UNITED STATES ENVIRONMENTAL PROTECTION AGENCY  
REGION 10

RE: *United States of America v. FMC Corporation*, No. CIV 98-0406-E-BLW (D. Idaho),  
RCRA Closure Plan for Pond 18 Cell A

Enclosure to Letter, dated January 2, 2002, Approving Initial  
Phase of Pond 18 Cell A Closure

Modifications to the August 2001 Closure Plan

BECHTEL ENVIRONMENTAL, INC. SAN FRANCISCO			
ASTARIS IDAHO, LLC POCATELLO, IDAHO			
Pond 18 FT-IR RELOCATION PLAN			
	Job Number	Drawing No.	Rev.
	24230	Figure 8-1	0

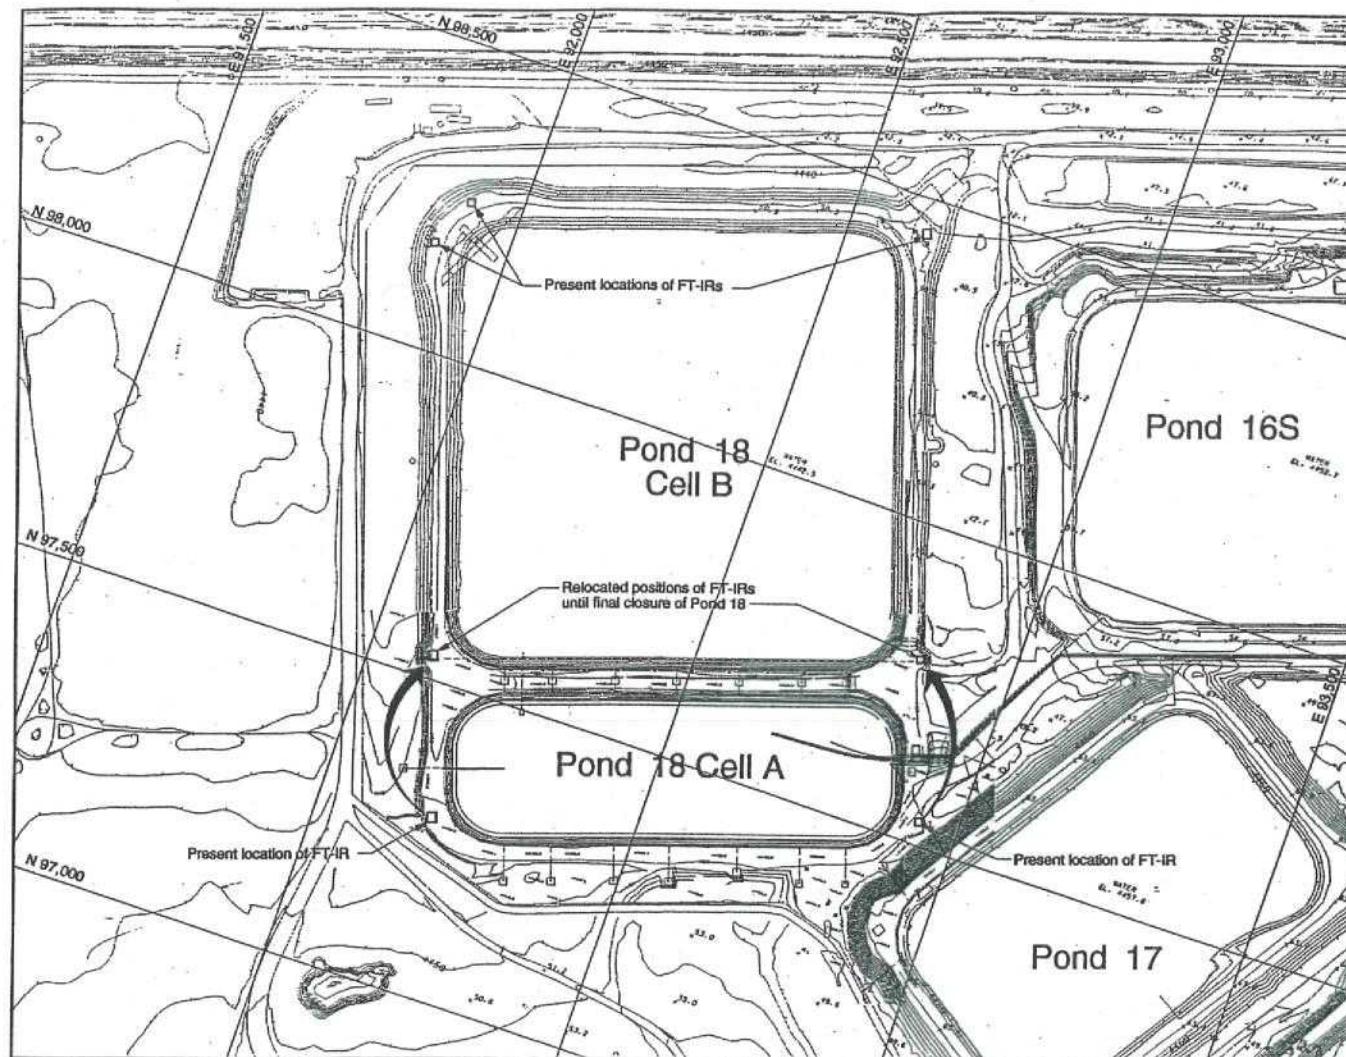
15) Section 8.6.2.2, Page 8-9. The future location of the Pond 18 FT-IR units identified on the attached Figure 8-1 is added to Section 8.6.2.2. The second paragraph of this section is replaced with; "It is anticipated that the FT-IR units may potentially interfere with widening of the perimeter dikes to accommodate the sewing and staging of the geofabric, and the conveyor equipment for the initial fill placement, at which time the units may have to be removed. The units will be relocated and reinstalled as indicated in Figure 8-1 (attachment 1), to monitor Cell B. During periods where the FT-IRs are inoperable, monitoring will continue to be performed by the construction work crews. Each work crew performing work in the pond area will have a personal phosphine monitor and work rules for all pond closure activities will be in full conformance to the requirements of the Plan Worker Safety Procedure as outlined in the RCRA Pond Management Plan, incorporated into Attachment A of the Consent Decree (PMP) and the Task-Specific Health and Safety Plan for Pond 18 (Appendix E of the Pond 18 Closure Plan). The personal phosphine monitor(s) have been and will continue to be a far more effective method for monitoring personnel exposures and taking appropriate action to minimize worker exposures. During periods when the FT-IRs are inoperable, concentrations of phosphine that reach 3.0 ppm or concentrations which remain between 1.0 and 3.0 ppm for more than 5 minutes in the pond area detected by monitoring performed by the construction crews using phosphine monitors shall require fenceline monitoring in accordance with Section 3.3.2.3 of the PMP as revised below.

- The FT-IR units located at the southwest and southeast corners of Cell A will be relocated to the southwest and southeast corners of Cell B during placement of the initial fill in Cell A. All five FT-IR units will be removed by completion of closure of Pond 18.
